MILITARY SPECIFICATION

CLAMP ASSEMBLY, SADDLE-TYPE, CUSHION, GENERAL
SPECIFICATION FOR

This amendment forms a part of Military Specification MIL-C-85449, dated 6 March 1981, and is approved for use by all Departments and Agencies of the Department of Defense.

FIGURE 2. Flammability test set-up (typical).

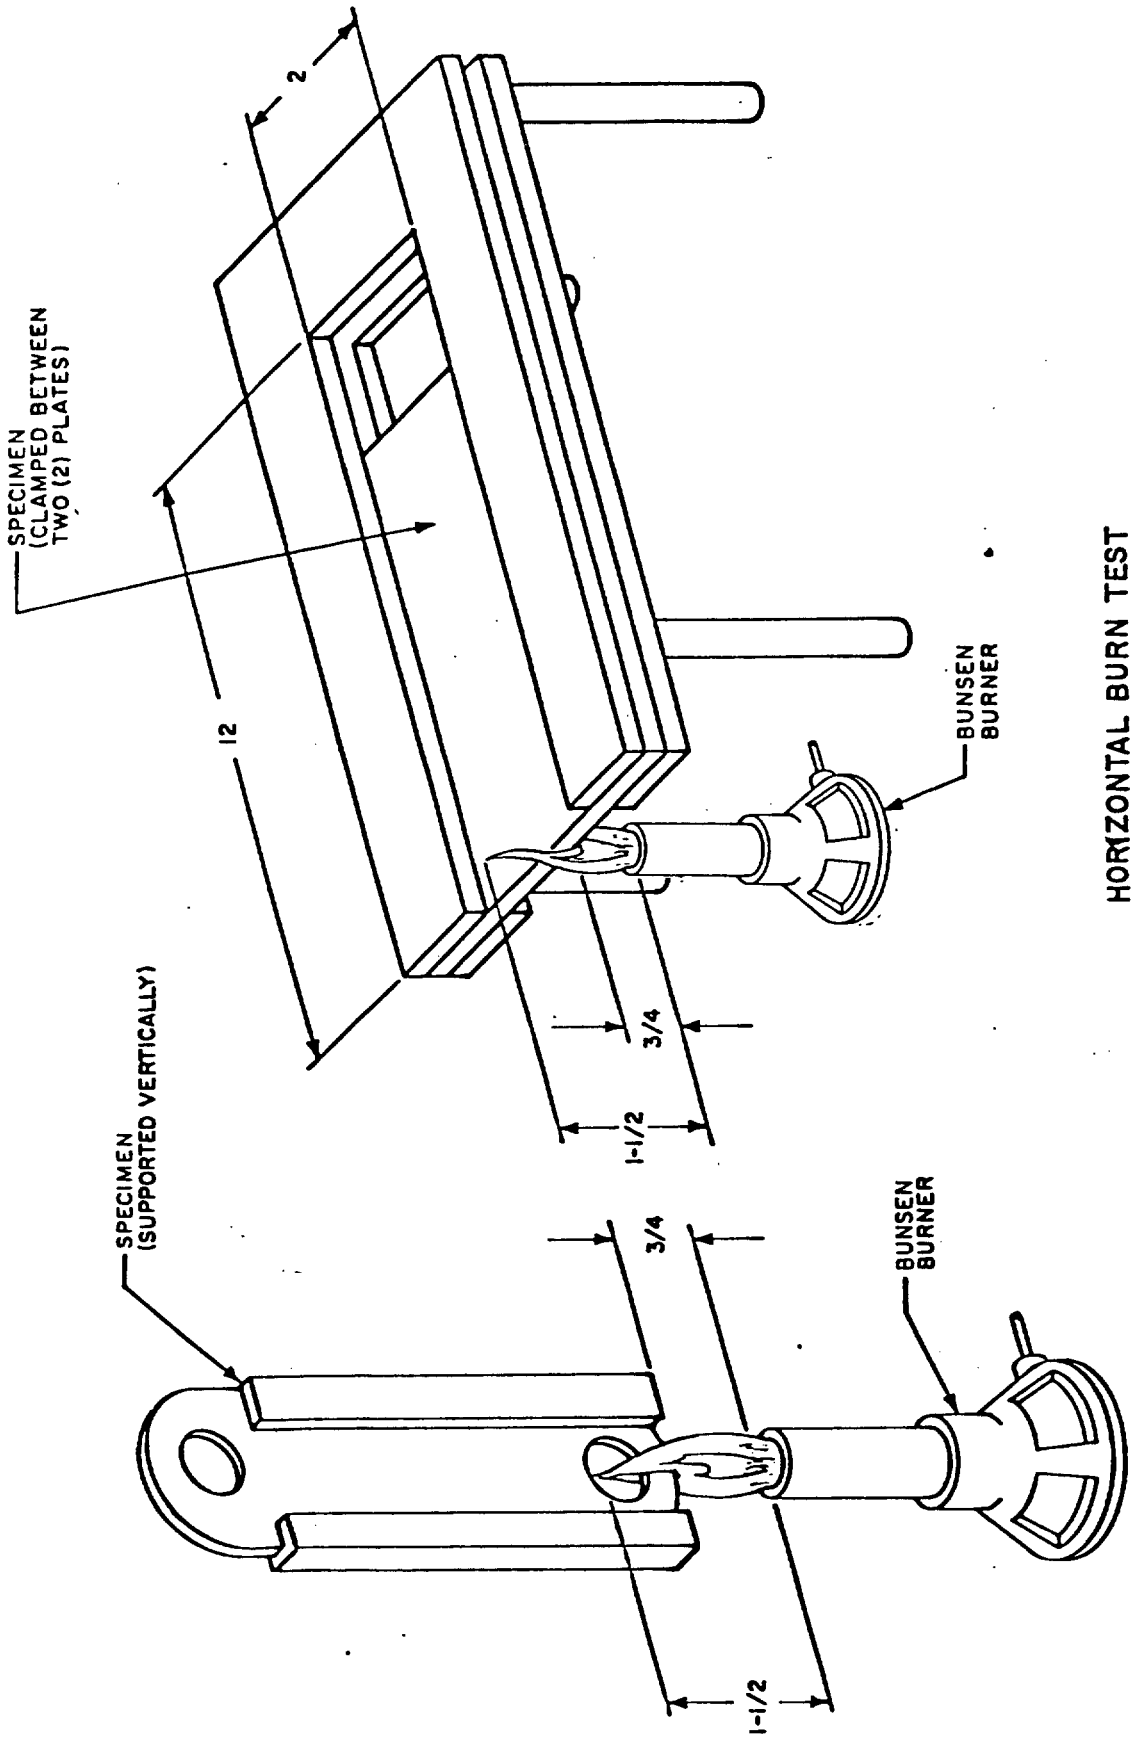
"4.5.3.3.2 Vertical burn test. Three size dash 16 clamps shall be used for the vertical burn test (see 4.5.3.3.1). Remove the specimens one at a time from the preconditioning chamber immediately before performing test. Slide the cushion to one end of the clamp band. Position the specimen in the vertical position with the centerline of the cushion material 3/4 inch above the top edge of the burner tube. Apply flame for 12 seconds and then remove. Testing shall be performed in a draft free environment. The average burn time of the three samples after removal of flame shall not exceed 15 seconds. The average burn length shall be less than the length of one of the specimens (cushion). Drippings from the burning specimens shall not continue to flame for more than 5 seconds after falling (see Figure 2)."

"4.5.3.3.3 Horizontal burn test. Three specimens fabricated in accordance with ASTM D3182 shall be used for the horizontal burn test. The specimens shall be removed one at a time from the preconditioning chamber and positioned so that the centerline of the edge being burned shall be 3/4 inch above the top edge of the burner tube. The flame shall be applied for 15 seconds and then removed. Permit a minimum of 1-1/2 inches to burn to calculate the burn rate. The burn rate shall not exceed 2-1/2 inches per minute. Record burn rate (see Figure 2)."
